ADDENDUM TO CERTIFICATE APPLICATION

Addendum to Section 4906-5-06, Subsection (D) Public Interaction and Economic Impact, of the Certificate Application

Duke Energy C314V Central Corridor Pipeline Extension Project

Instructions for Replacement Pages and One Map Figure Addition

8-4A-R Slope Greater Than 12 Percent and Soil Erosion Hazard Within 1,000 Feet of Pipeline

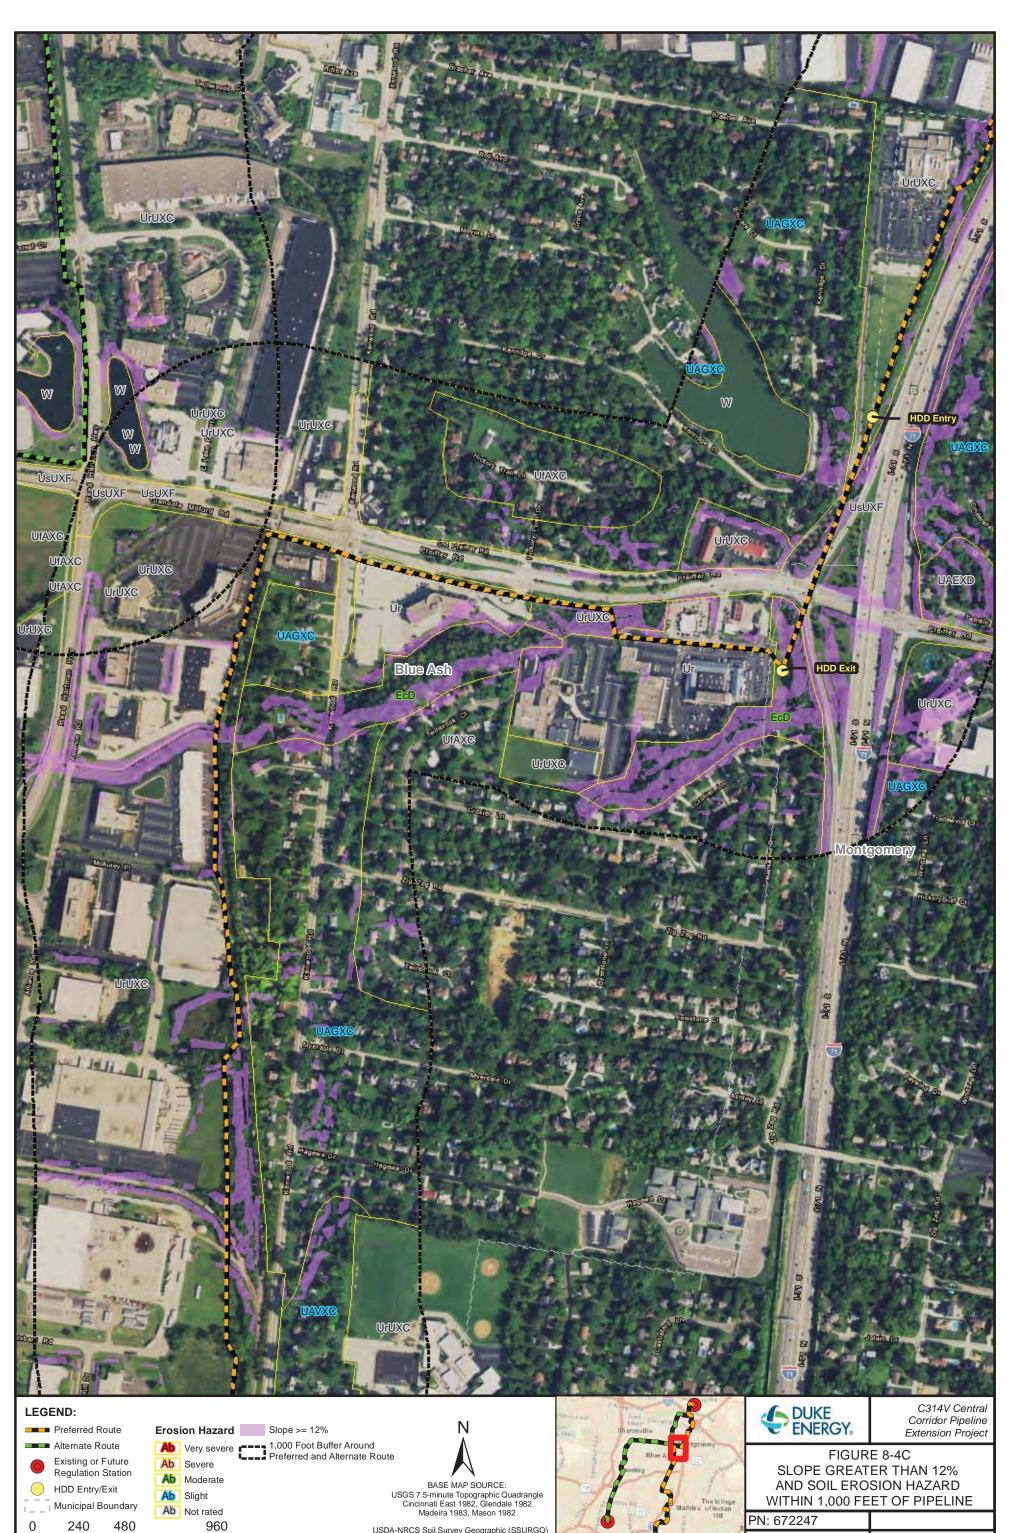
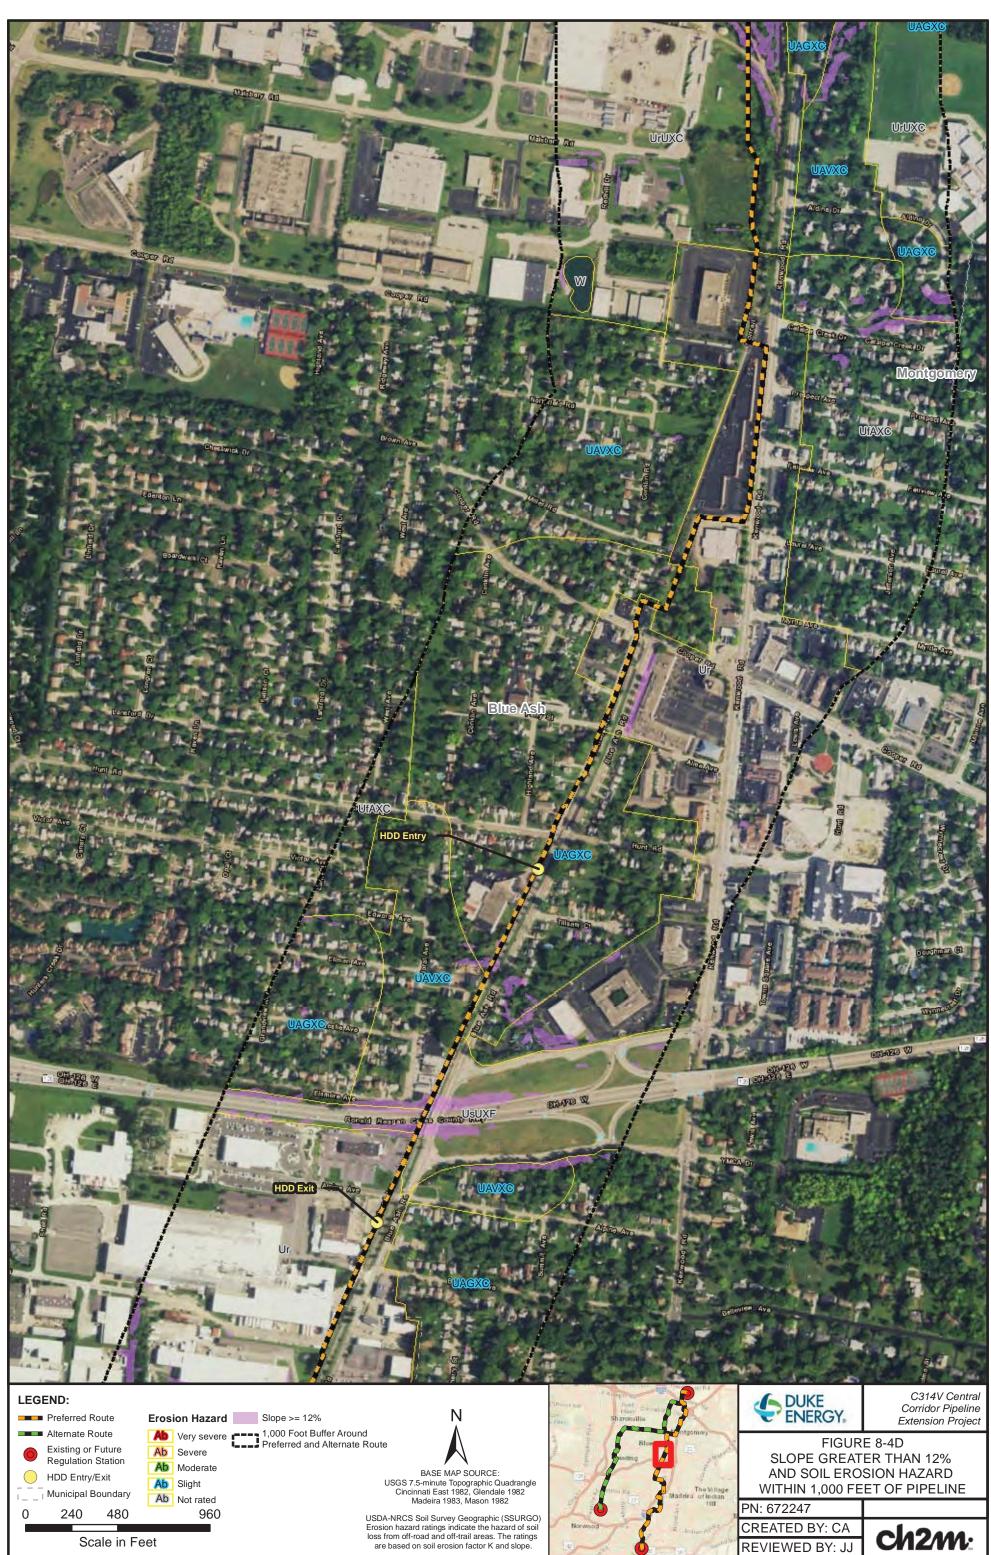
Figure 5-1:	Project Features and Cultural Resource Map (added existing electric transmission lines)
(NEW) Figure 8-4A through 8-4R:	Slope Greater Than 12 Percent and Soil Erosion Hazard Within 1,000 Feet of Pipeline

Figure 8-4A through 8-4-R illustrates areas having greater than 12 percent slopes as well as the soil erodibility ratings.
